Stabilizers – Vertical Stabilizer – Delivery of complete VTP to Final Assembly Lines

MODIFICATION APPROVAL SHEET
MOD No. 55760

Stabilizers – Vertical Stabilizer – Delivery of complete VTP to Final Assembly Lines
RFC No.*
QUERY No.*
RFW No.*
REF No.* M 18035

ISSUE* D 4

PRE – MOD A330/A340-300

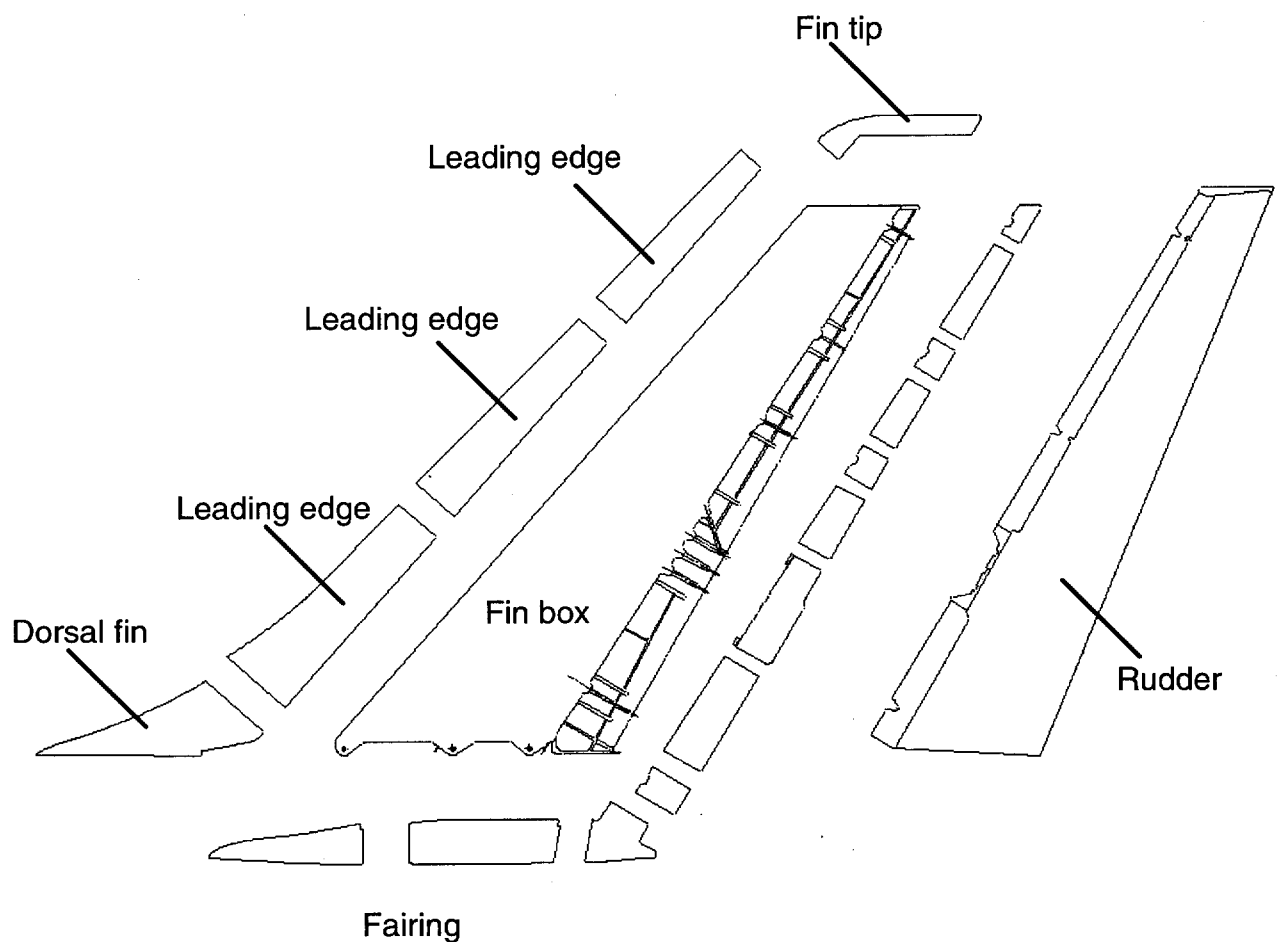
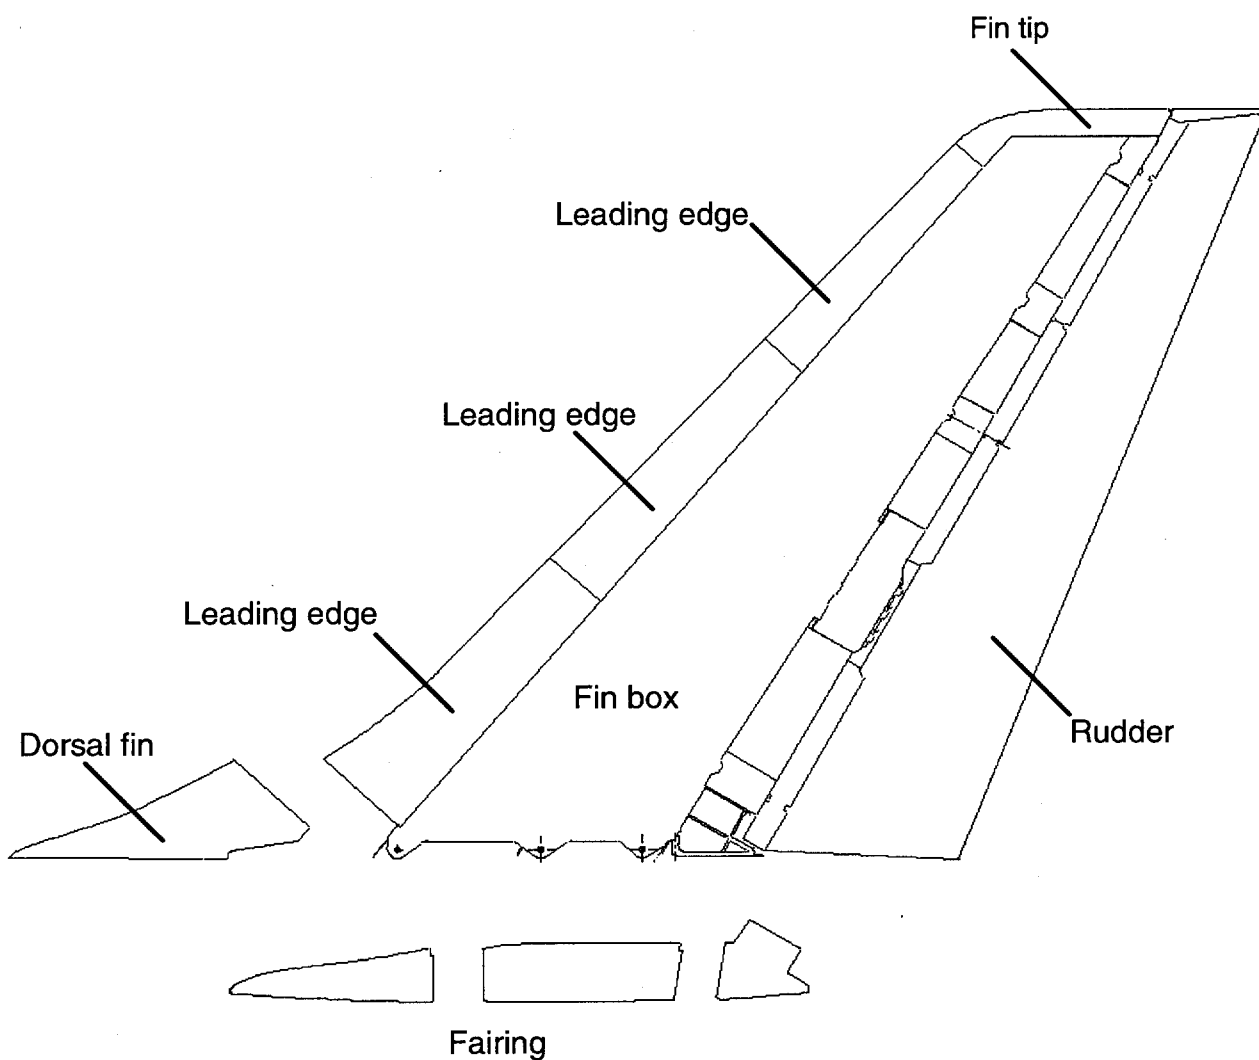
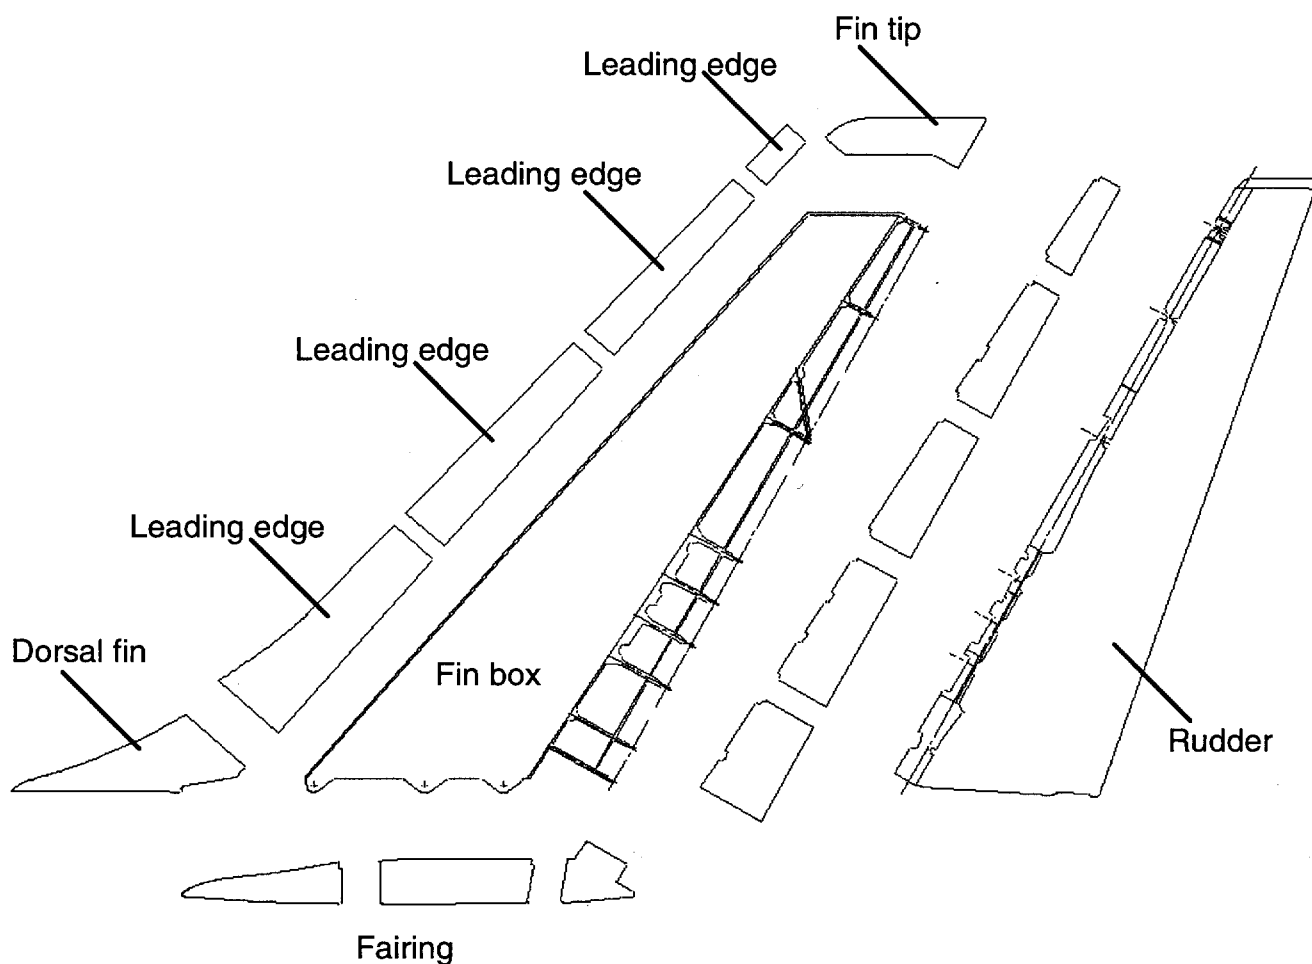
In order to change the location of the VTP–final assembly, the adaptation of existing drawings and the preparation of new drawings are necessary.
Also the GTR must be adapted.

The affected drawings, now in use for the assembly in Toulouse are :

45 F553-71700 valid for A330–200, A340–500 and A340–600

45 F553-70600 valid for A330–300 and A340–300

POST – MOD
A330/A340-300 (ST4,ST8)

(new Drawings)

PRE-MOD

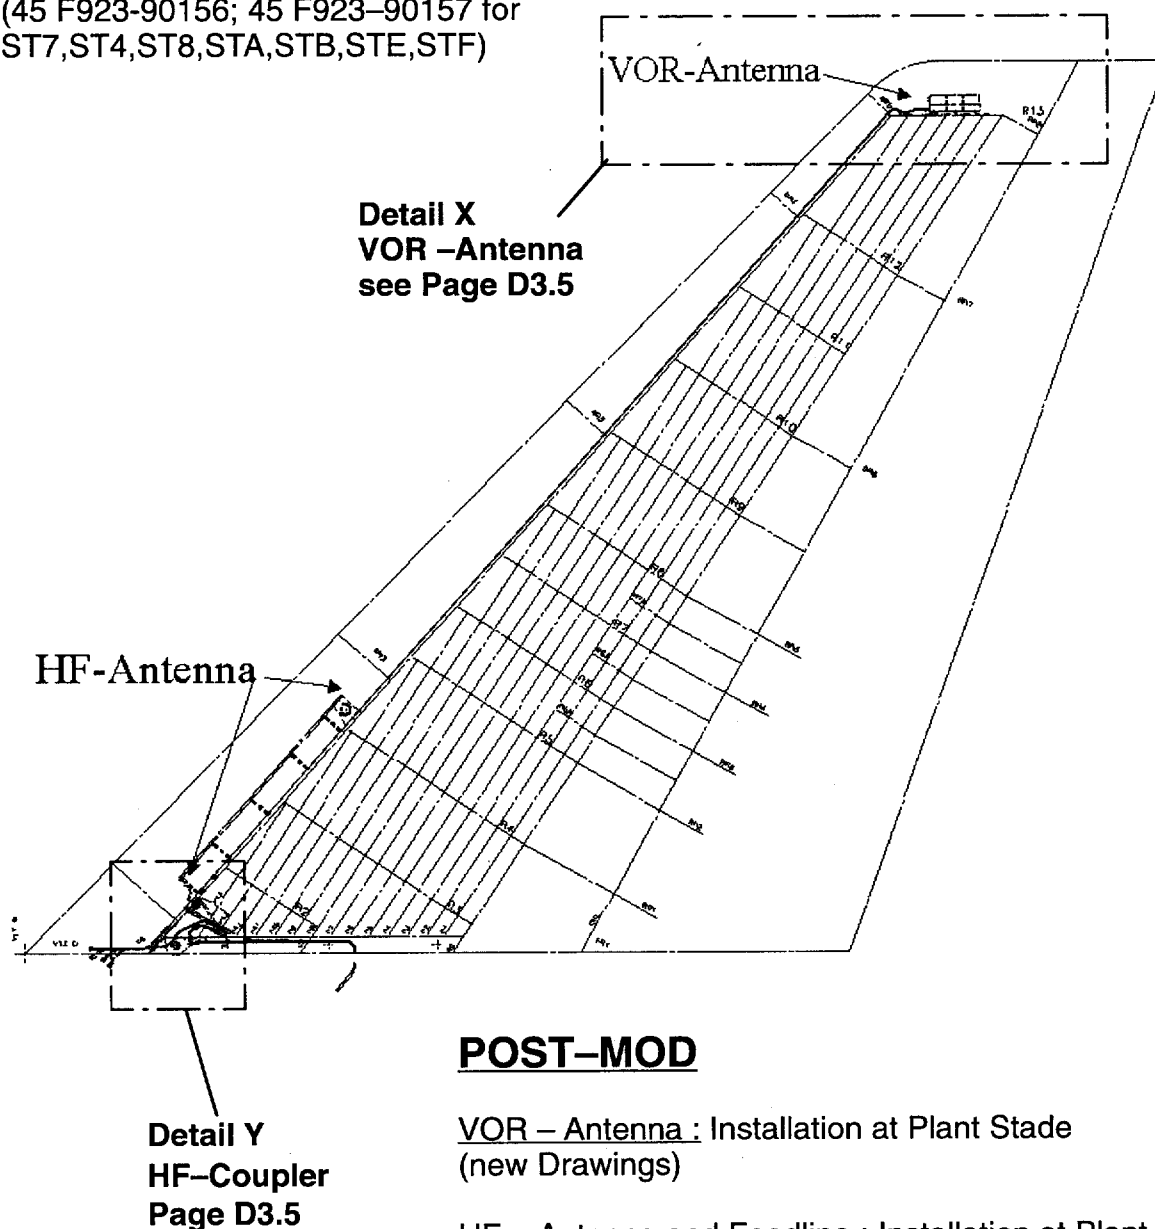
VOR – Antenna : Installation at FAL Toulouse
(45 F923-90159 for ST7,ST4,ST8)
(45 G923-90159 for STA,STB,STE,STF)

HF – Antenna and Feedline : Installation at FAL Toulouse
(45 F923-90158 for ST7,ST4,ST8,STA,STB,STE,STF)

HF – Coupler : Installation at FAL Toulouse
(45 F923-90156; 45 F923-90157 for
ST7,ST4,ST8,STA,STB,STE,STF)

POST-MOD

VOR – Antenna : Installation at Plant Stade
(new Drawings)

HF – Antenna and Feedline : Installation at Plant Stade
(new Drawings)

HF – Coupler : Installation at Plant Stade
(new Drawings)

Detail X

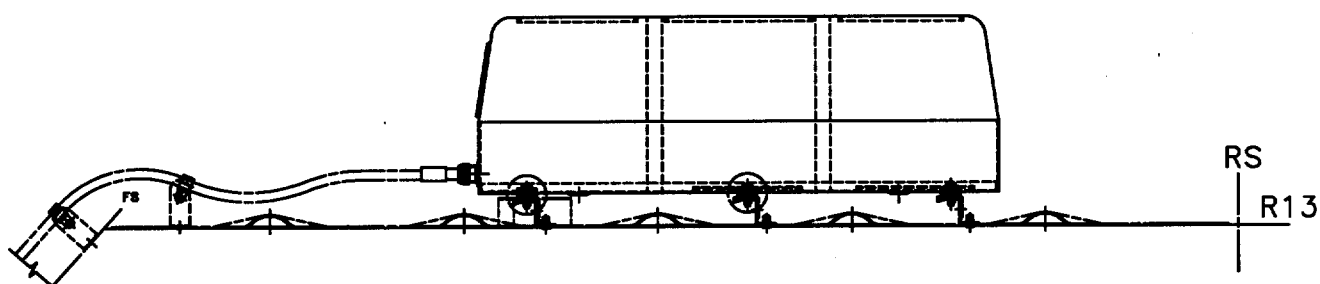
Preparation of new Installation-drawings for the VOR-antenna .

The affected drawings, now in use for the assembly in Toulouse are :

45 F923-90159 for A330-200, A330-300 and A340-300

45 G923-90159 for A340-500 and A340-600

Detail Y

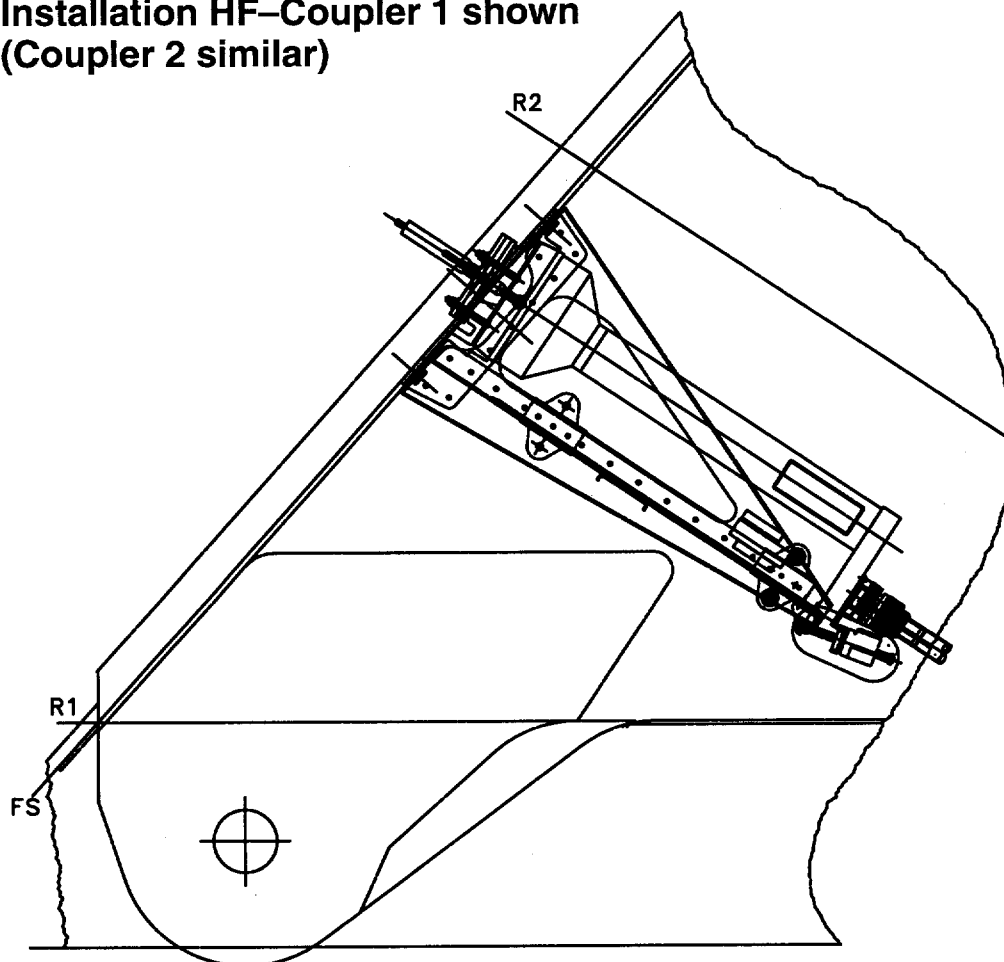
Preparation of new Installation-drawings for the HF-antenna-feedline and the HF-coupler.

The affected drawings, now in use for the assembly in Toulouse are:

45F923-90158; 45F923-90156 for A330-200, A330-300, A340-300, A340-500, A340-600

ELECTRICAL INTERFACES

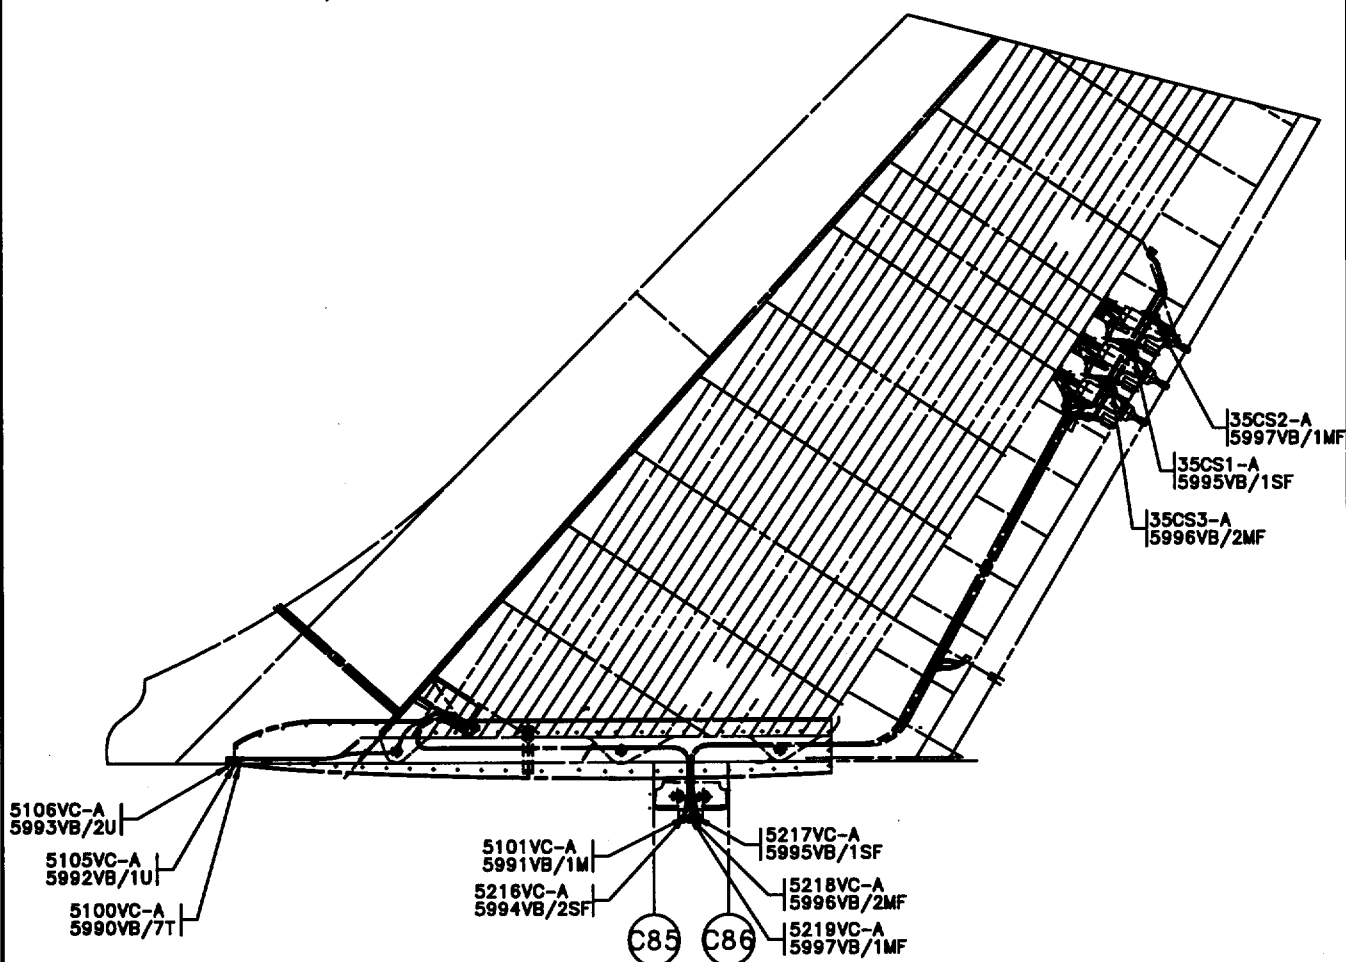
PRE – MOD

Electrical Interfaces : Installation at FAL – Toulouse

45 F928 90499 (A330/A340-300)

45 G928 90499 (A330-200, A340-500/600)

POST – MOD

Electrical Interfaces : Installation at Stade
Plant

(new drawings)
* FOR INFORMATION ONLY, NON APPROVED DATA
